ADDENDUM NUMBER TWO (2)

Project: Health Sciences Complex (Rankin Campus)
Hinds Community College
Pearl, MS
HCC Bid #3298
PN: 21041

FROM: Dean Architecture, P.A.
661 Sunnybrook Road, Suite 140
Ridgeland, MS 39157
(601) 939-7717

1 OVERALL ROOF PLAN
 A110 SCALE: 1/16" = 1'-0"

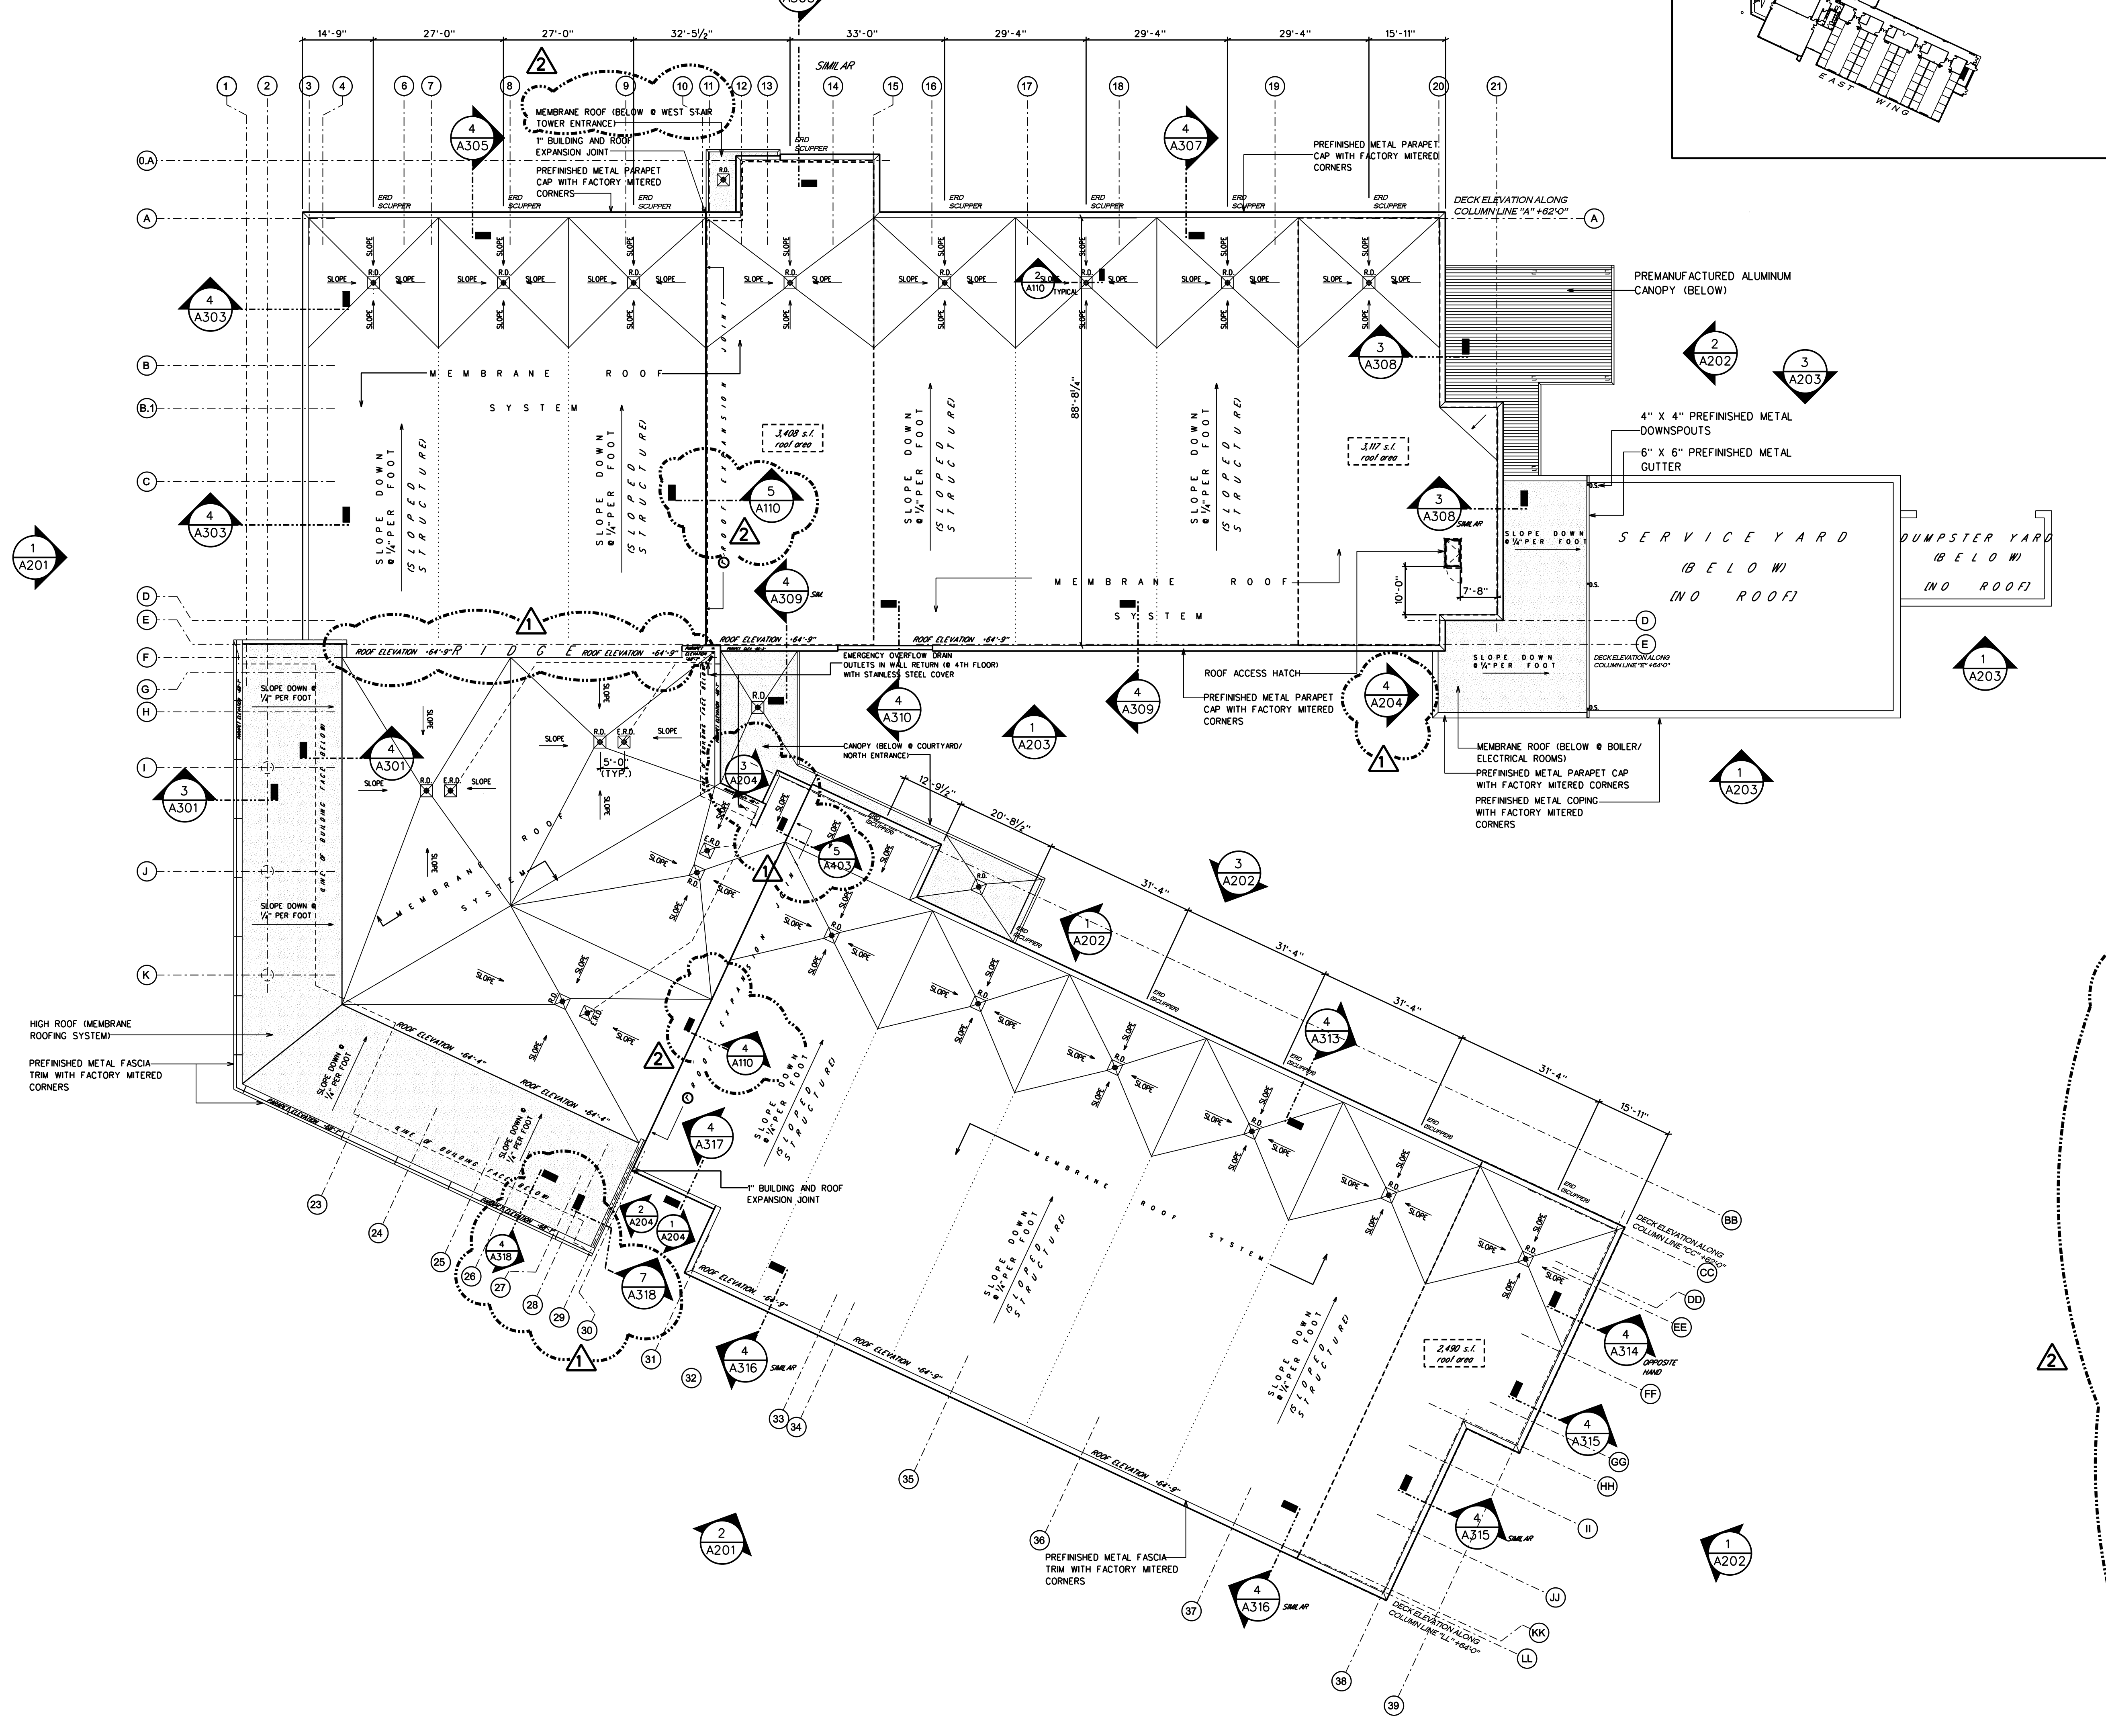
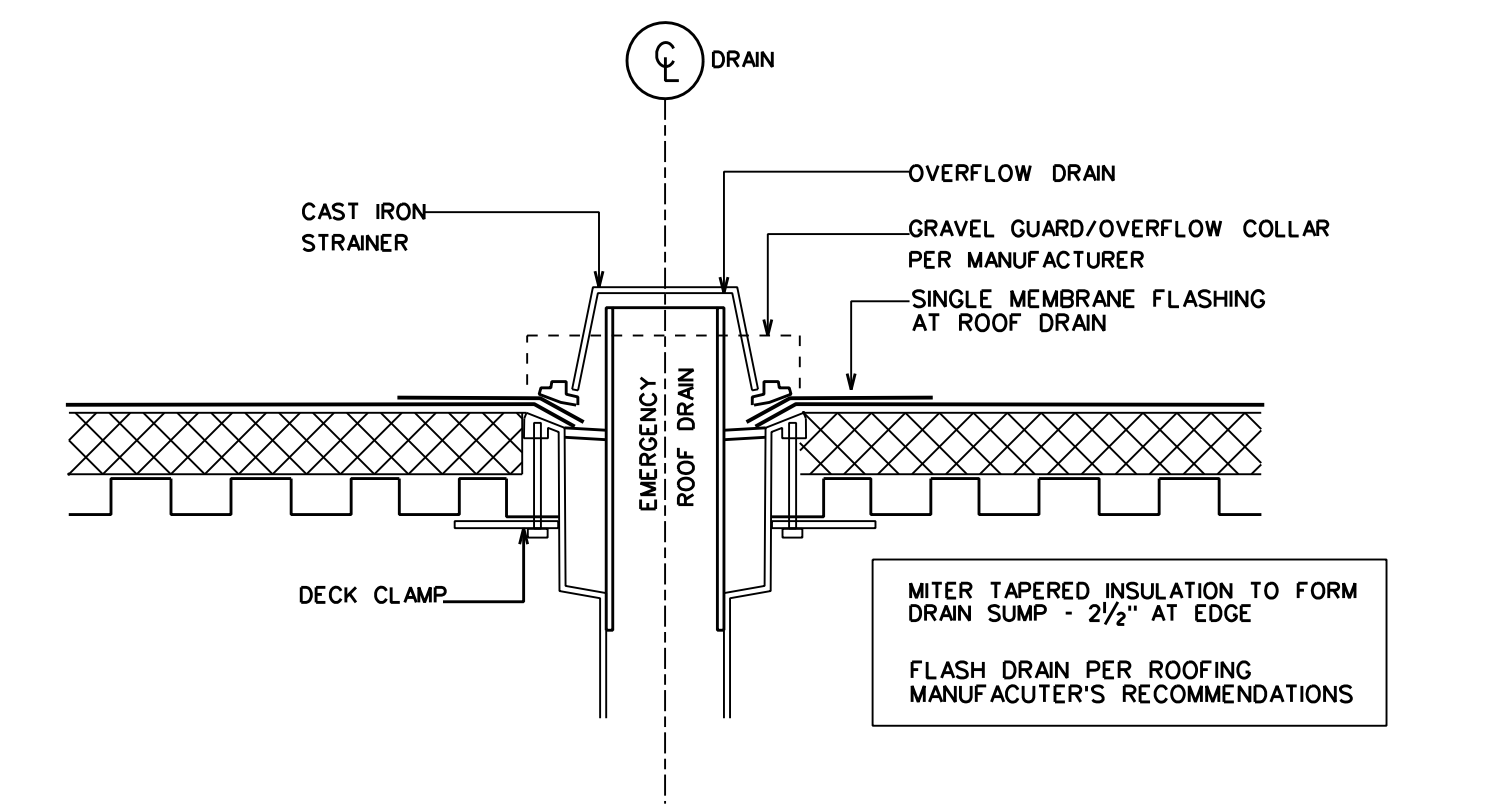
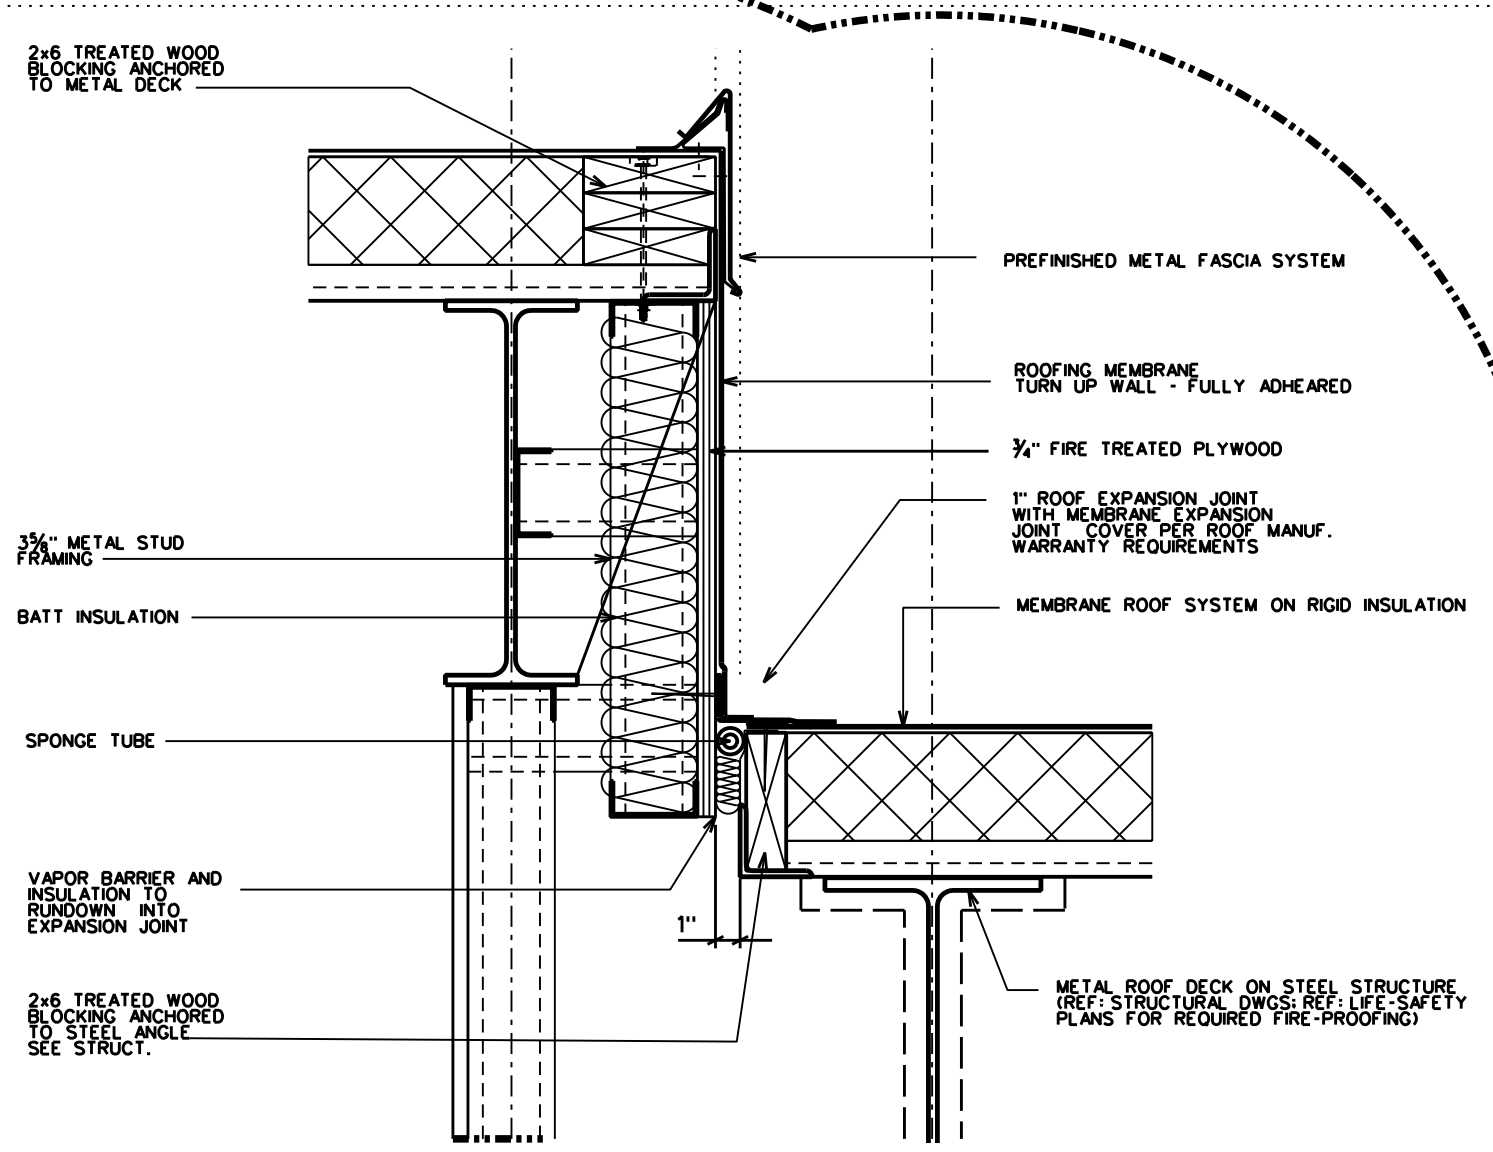
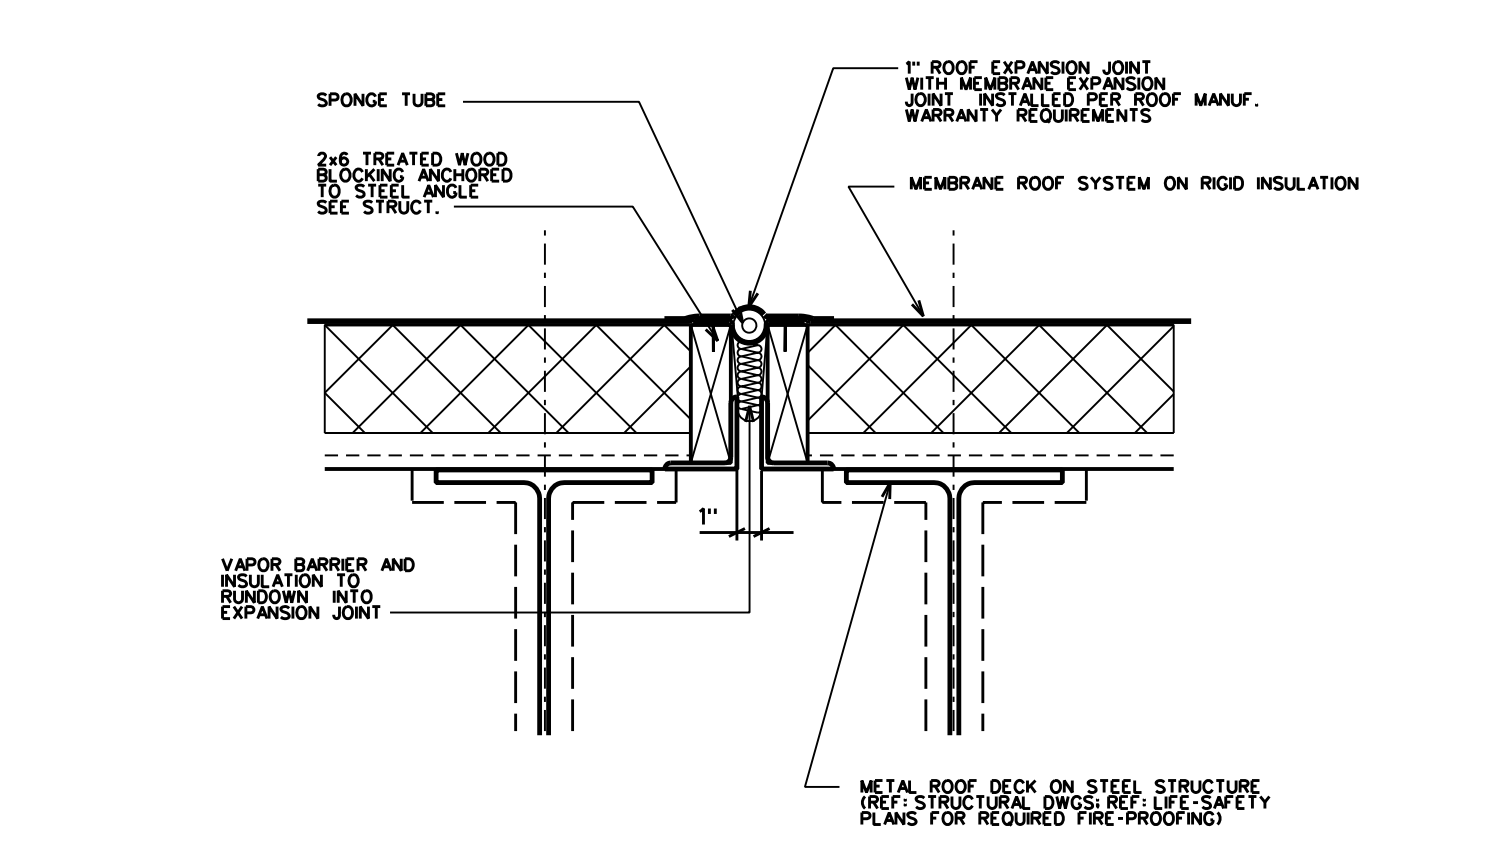
- Item #1:** Sheet A110, Overall Roof Plan, as follows:

Remove existing sheet and replace with revised sheet A110 dated 5/7/2024.
Corrected note at West entry roof and added roof expansion joint details.
- Item #2:** Sheet A204 – Exterior Elevations
